# **PUBLIC COMMENT REPORT**

## **PUBLIC COMMENTS RECEIVED ON FIRST PUBLIC REVIEW DRAFT**

## **ICC/ANSI A117.1 STANDARD DEVELOPMENT - 2014 EDITION**

## **ICC A117.1 Standard – Accessible and Usable Buildings and Facilities**

IMPACT OF PROPOSED CHANGES TO T-TURN

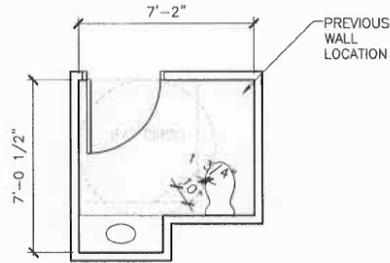
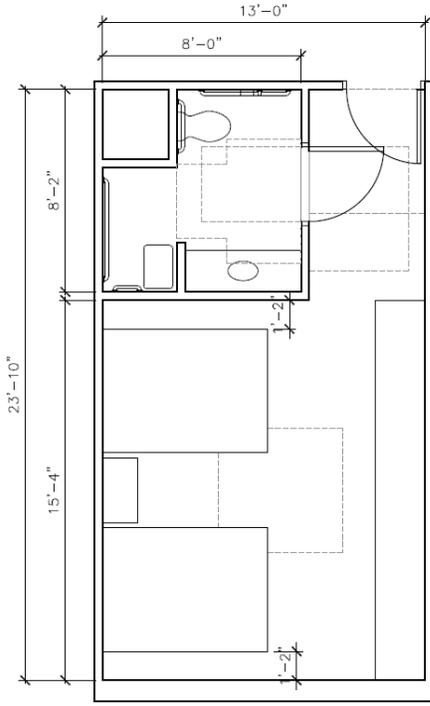
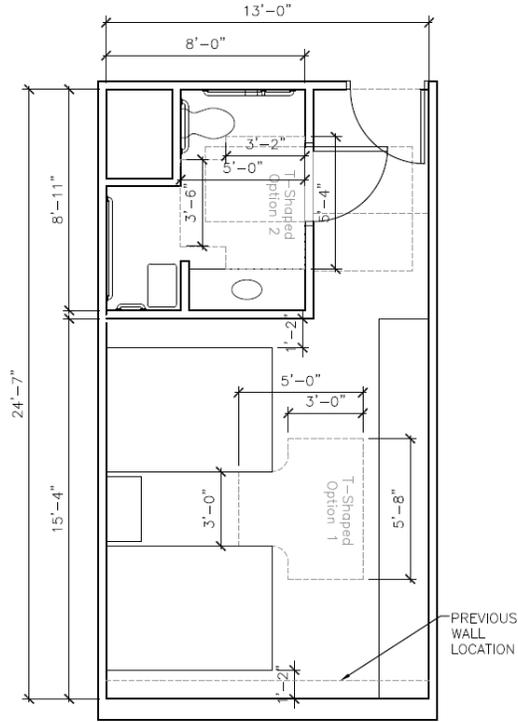
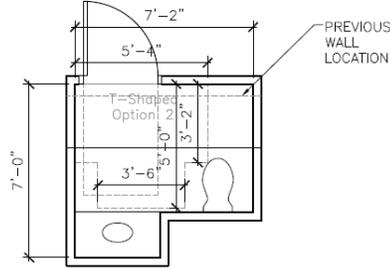
- INCREASE IN ROOM SIZE: 14 SQ. FT.
- COST PER SQ. FT. OF CONSTRUCTION: X
- ADDITIONAL COST PER ROOM = 14 x X

- INCREASE IN ROOM SIZE: 4.5 SQ. FT.
- COST PER SQ. FT. OF CONSTRUCTION: X
- ADDITIONAL COST PER ROOM = 4.5 x X

- INCREASE IN ROOM SIZE: 5 SQ. FT.
- COST PER SQ. FT. OF CONSTRUCTION: X
- ADDITIONAL COST PER ROOM = 5 x X

- INCREASE IN ROOM SIZE: 10 SQ. FT.
- COST PER SQ. FT. OF CONSTRUCTION: X
- ADDITIONAL COST PER ROOM = 10 x X

- INCREASE IN ROOM SIZE: 3.5 SQ. FT.
- COST PER SQ. FT. OF CONSTRUCTION: X
- ADDITIONAL COST PER ROOM = 3.5 x X

FIG. 804.2.1  
PASS-THROUGH KITCHEN CLEARANCE

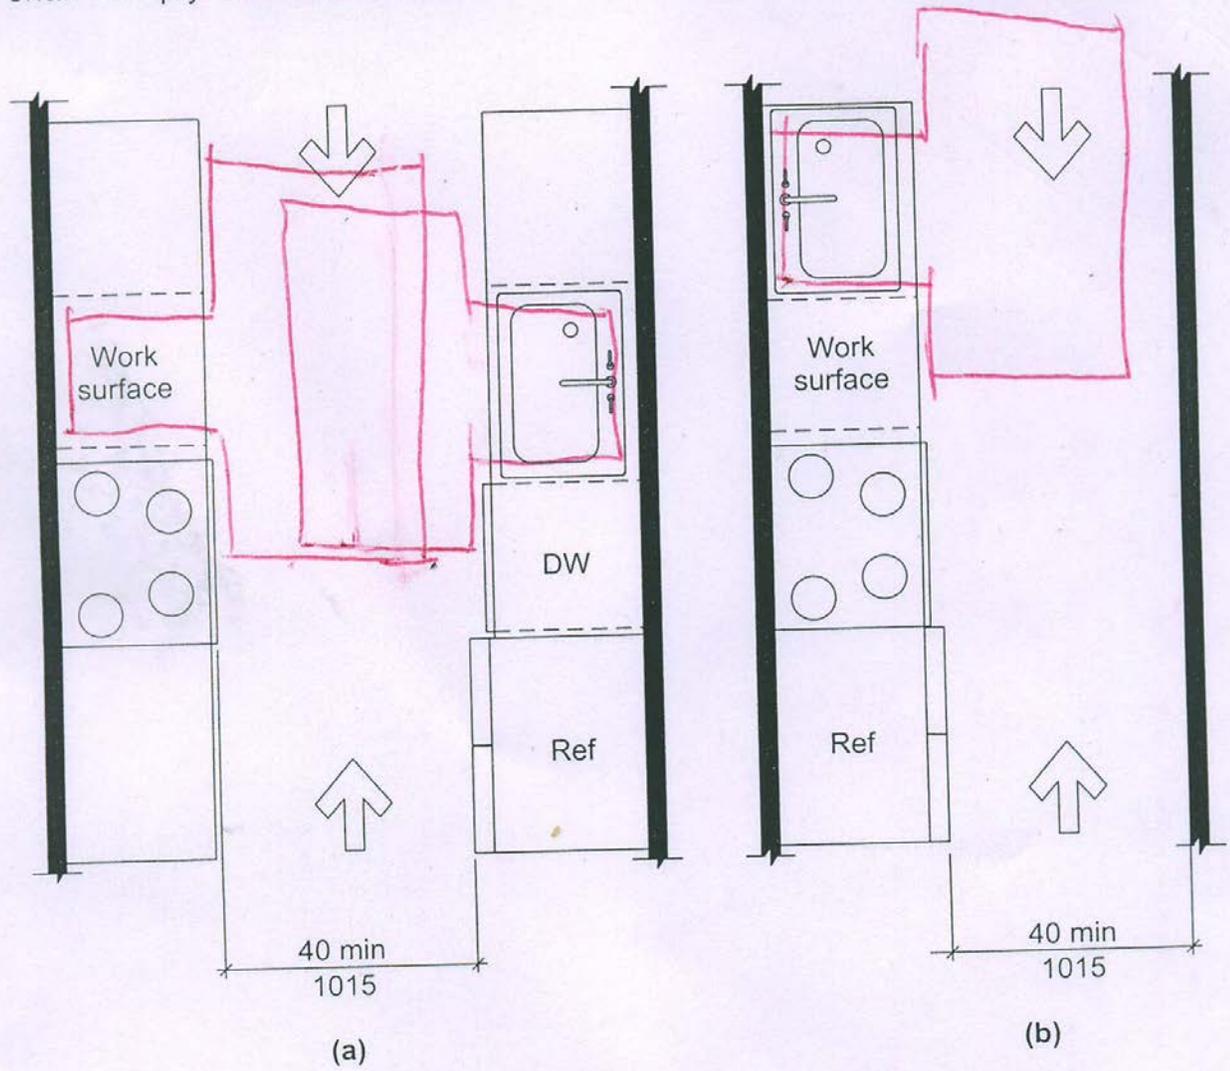
The new exception is intended to allow for some design options in kitchens. If that turning space is provided in U-shaped kitchen under the sink or work surface, then the provisions to access each side of the kitchen is addressed through the alcove provisions (which the committee decided to leave at 60".) If a T-turn is not provided because the work surface or sink is near a corner, then the space between the counter will provide a circular space. See figures for examples. In addition, this will maintain the 15 step work triangle which is important to the efficiency of a kitchen for standing persons.

shall comply with 804.2.1

Figure 304.3.1

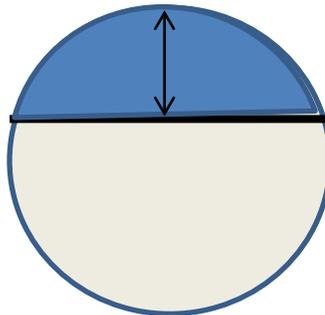
**Reason:** The intent of the original proposal was to eliminate the 'donut' effect currently permitted with the turning circle. However, in order to be consistent with the T-turn in Section 304.3.2, the depth on that one side should be permitted to be the same depth as the knee and toe clearance provided.

**304.3.1 Circular Space.** The turning space shall be a circular space with a ~~60-67 inch (1525 1700 mm)~~ minimum diameter. The turning space shall be permitted to include knee and toe clearance complying with Section 306. Where the turning space includes knee and toe clearances under an obstruction, the overlap shall comply with all of the following:

- ~~1. The depth of the overlap shall not be more than 10 inches (255 mm), and~~
- ~~2~~ 1. The depth shall not exceed the depth of the knee and toe clearances provided, and
- ~~3~~ 2. The overlap shall be permitted only within the turning circle area shown shaded in Figure 304.3.1.

**FIGURE 504.1**

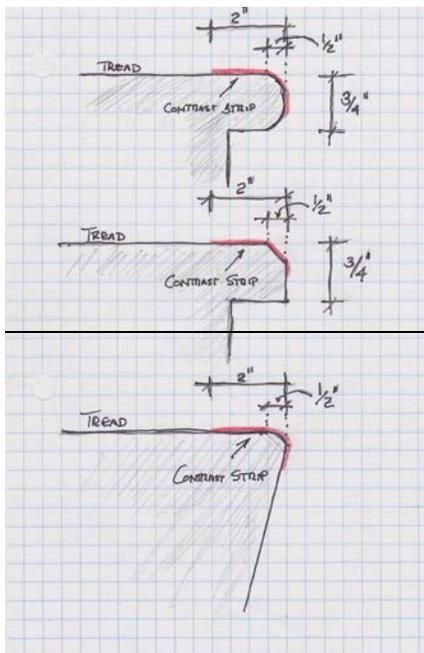
**Reason:** The concept in Proposal 5-13-13 has great merit, but the committee was unable to agree on adequate language to describe the contrasting edge stripe so that it is clear as to what is required. The proposed language and figure do that.

**505.5.1.2** The contrasting color of the leading edge of the tread or landing shall:

- a. Extend the full width of the tread or landing.
- b. Start at a line 2 inches (51 mm) back from the furthest point of the nosing and,
- c. Extend on the tread or landing toward the nosing, perpendicular to the path of travel, continuing to cover the profile of the nosing and down the riser until the color has extended 3 inches (75 mm) from the start line.

**DESIGN W/ NEW PROPOSED  
STANDARD**

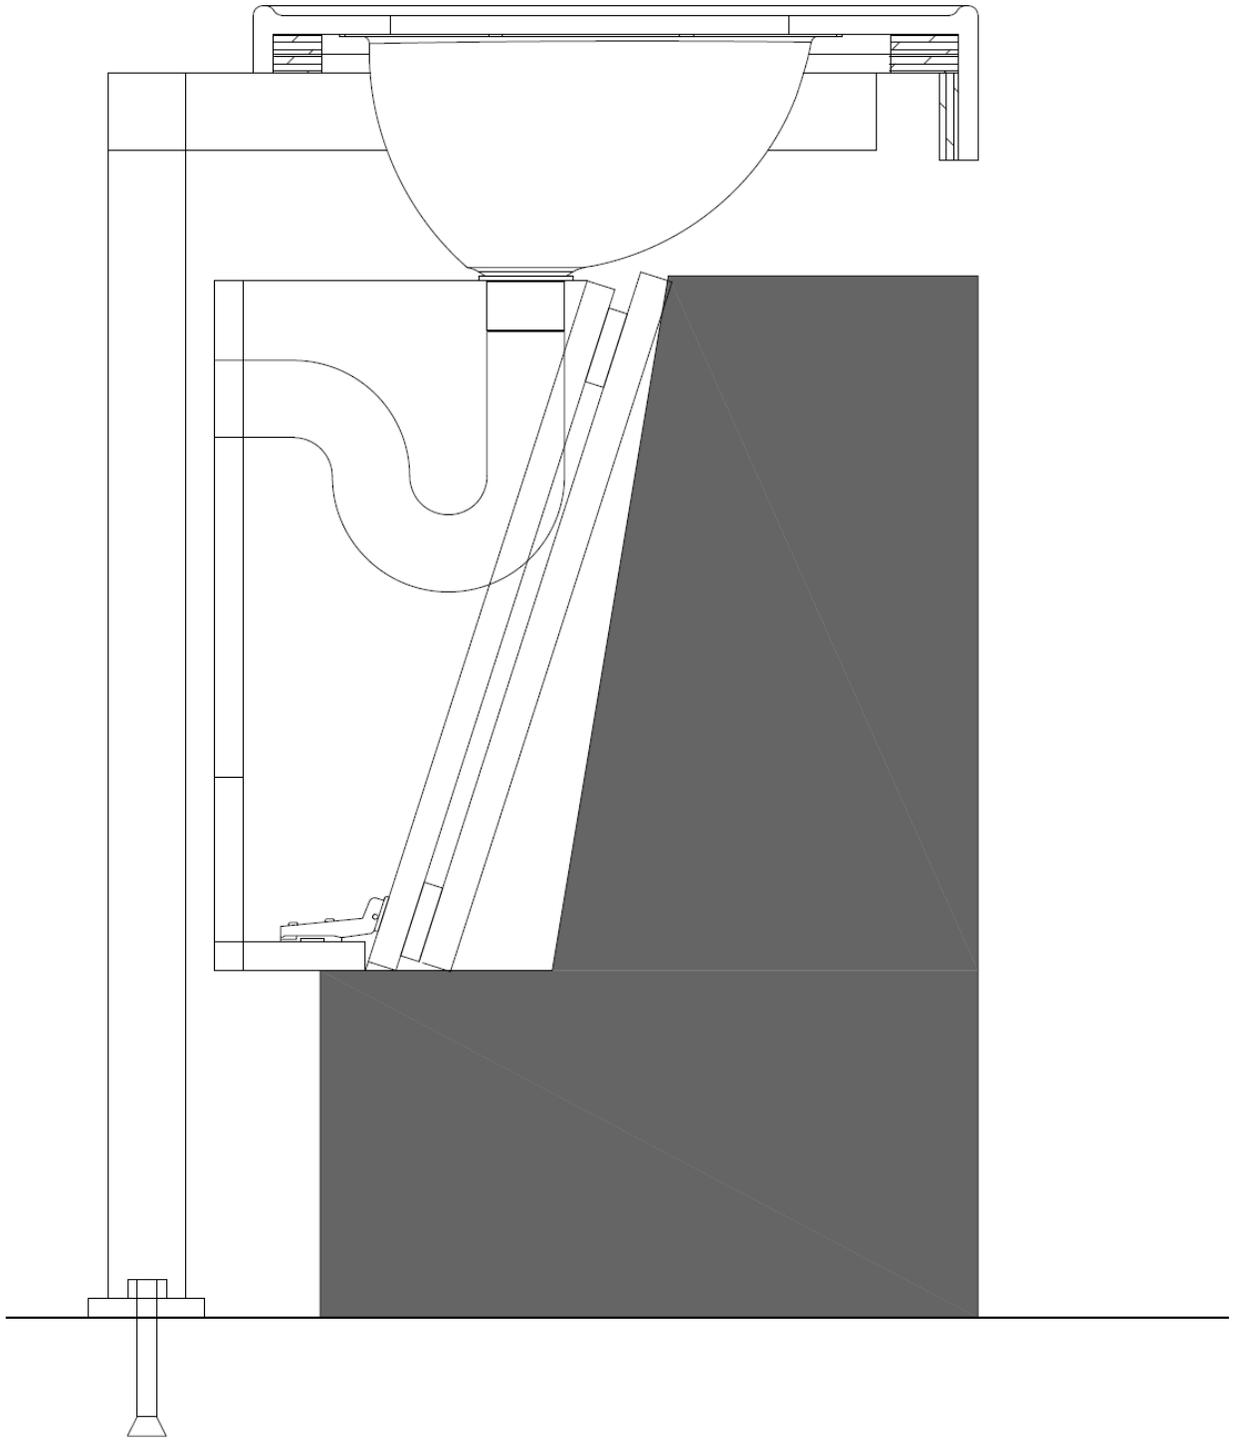
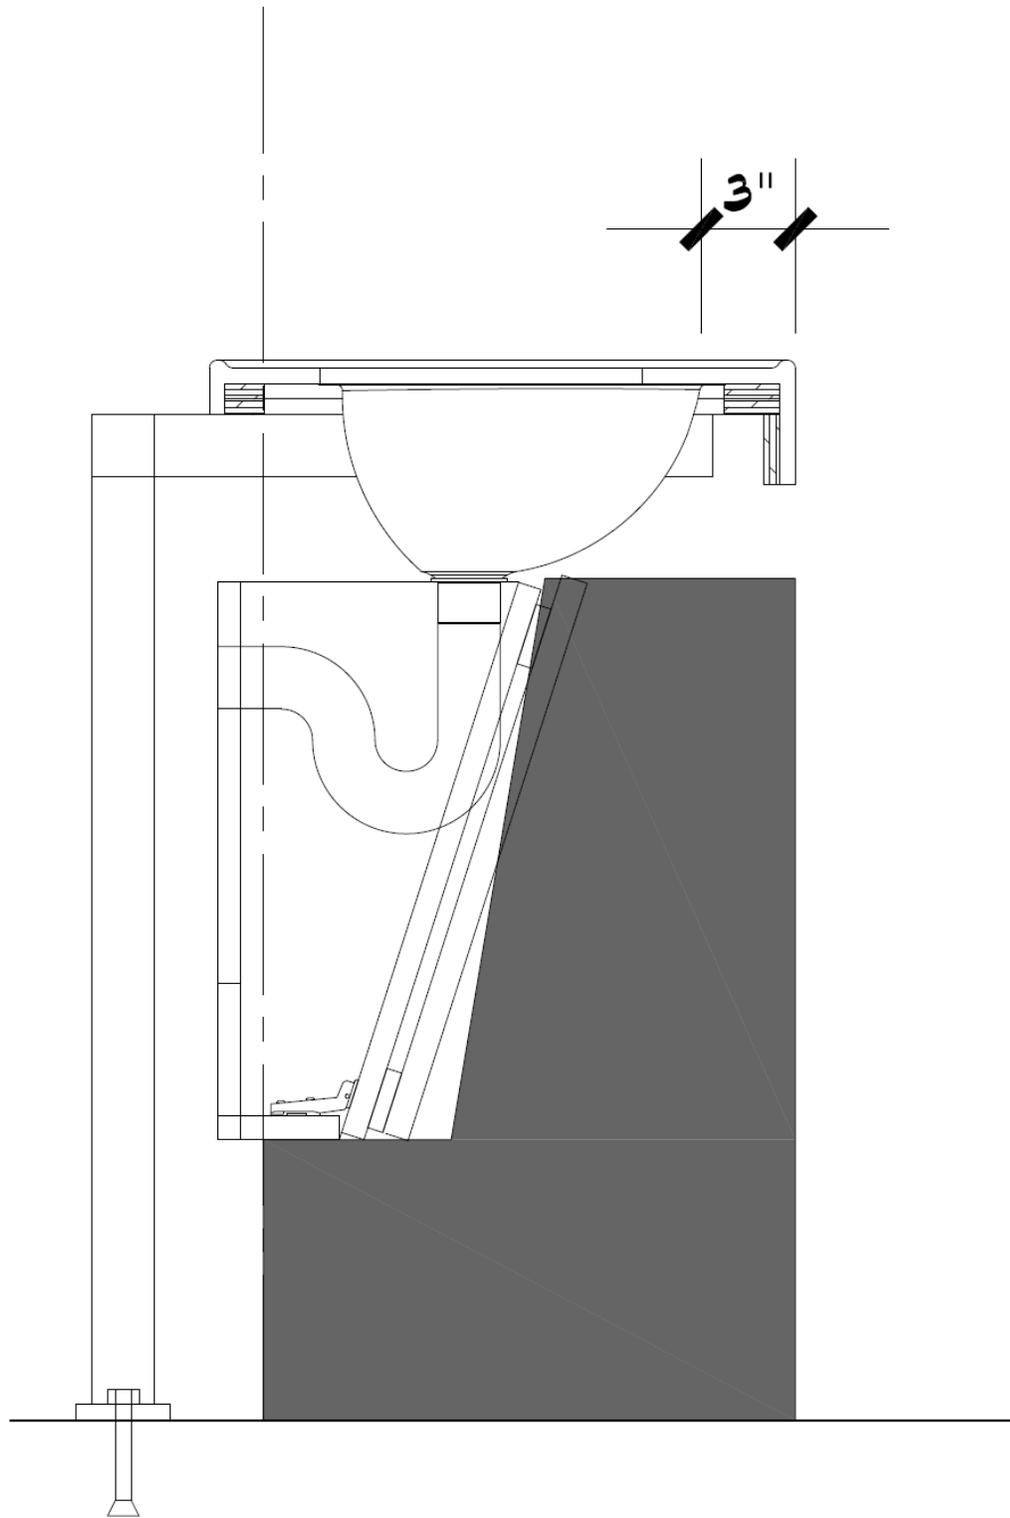
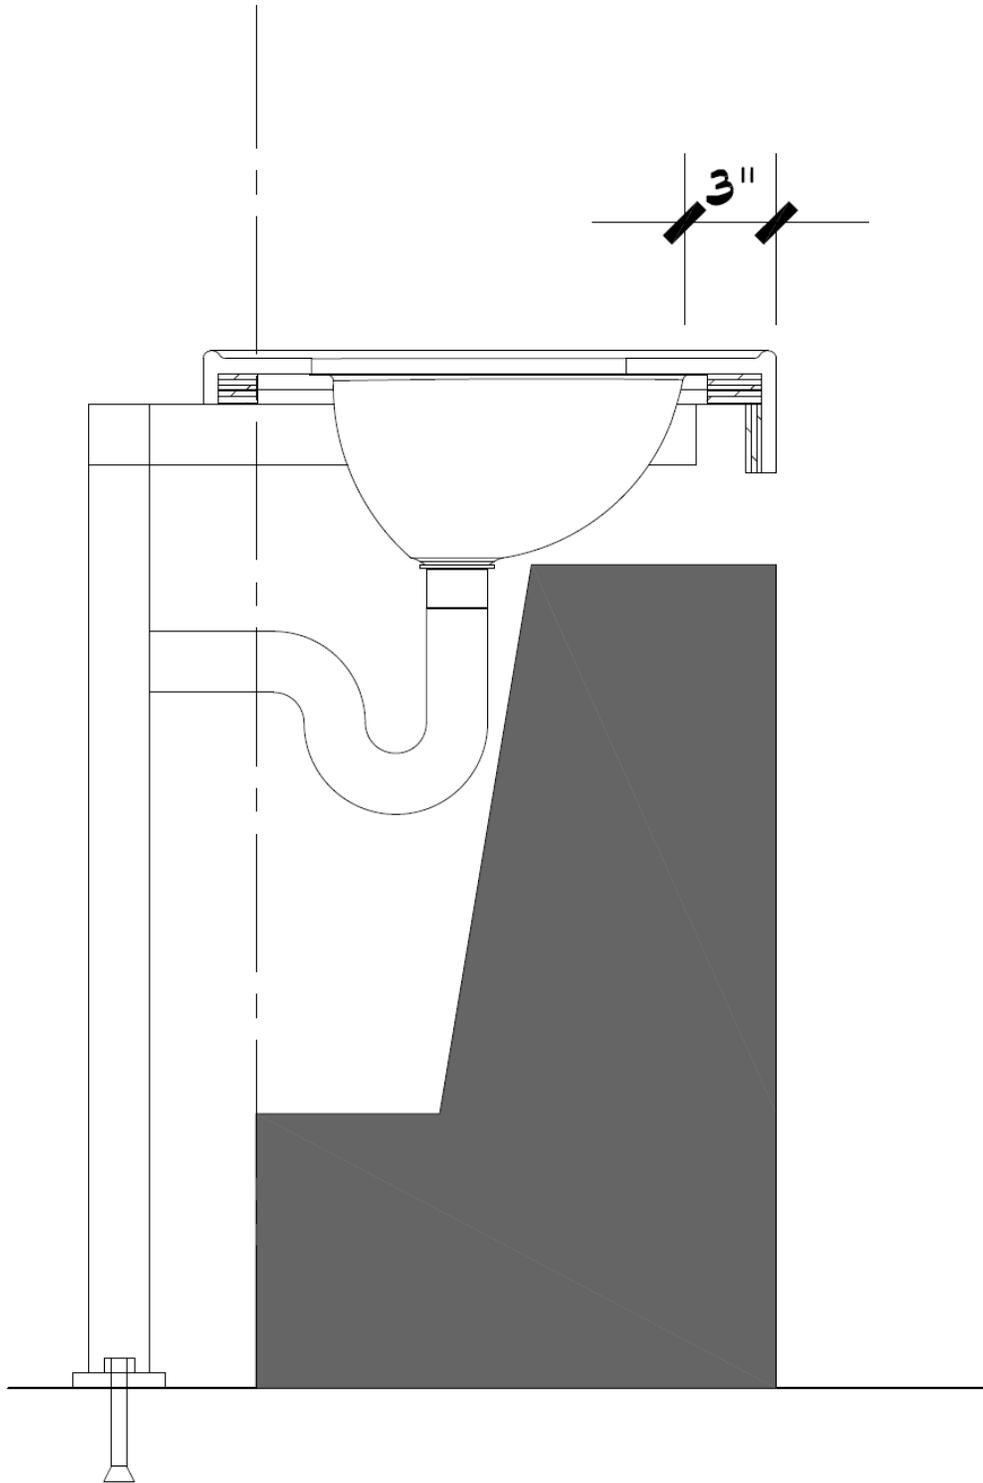
**Reason:** At the current 3" the from the front edge most sinks would not be able to comply with the required knee clearance. It would be impossible to meet the 8" deep requirement.

**FIG. A**  
 DISTANCE FROM OUTLET TO CFS IS  $27\frac{1}{2}$ "  
 COMPLIANCE WITH 309.2 CANNOT BE ACHIEVED AS A  
 RESULT OF THE PROJECTING RANGE

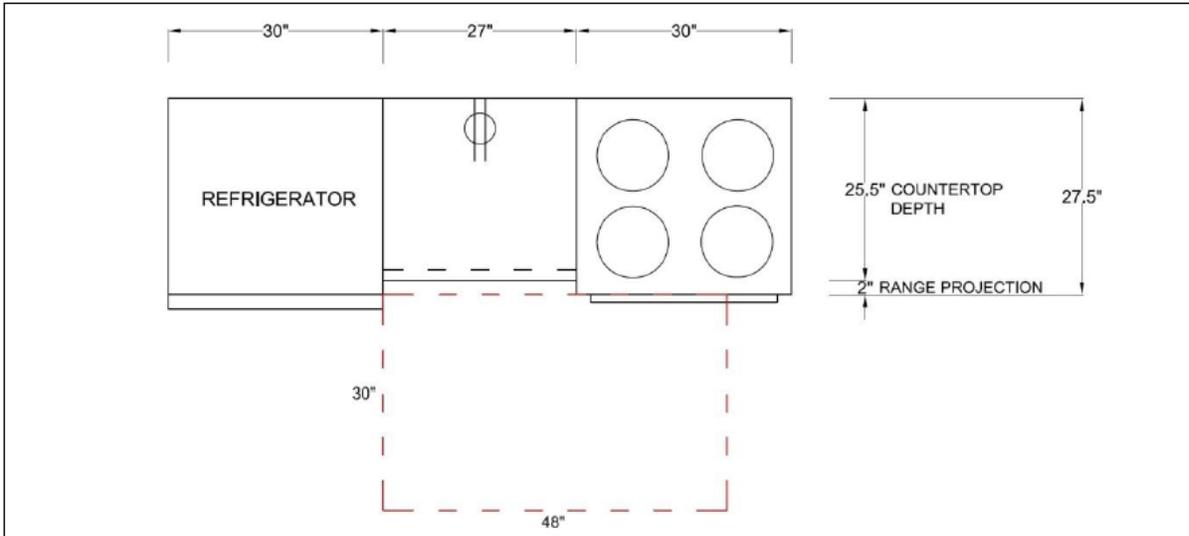
Compliance with proposed language at 1004.9, exceptions 2 and 3 is not possible to achieve if countertops less than 48 inches are located between appliances which project beyond the front edge of the countertop; when they project beyond the front edge of a standard 25½-inch deep countertop, they essentially "push" the clear floor space required by 309.2 (1004.9, Exception 2) too far away from the edge of the countertop rendering the outlet installed at the backsplash unreachable and inaccessible.

For example, if an outlet was located over a 27-inch wide base cabinet (assume 25½-inch deep conventional countertop) flanked on one side by a refrigerator, which projects beyond the countertop edge by 4 inches, and a range on the other side, which projects beyond the front edge of the countertop by 2 inches; then 48-inch long clear floor space positioned for a side approach to the outlet will never be close enough to the edge of the countertop such that the outlet located over it is reachable (see Fig. A). Essentially, accessible reach supported by a side approach in Type B units cannot be achieved unless there is enough space to align the 48-inch long clear floor space such that it is not "pushed" away from the front edge of the countertop by obstructions such as appliances or walls (see Fig. B).
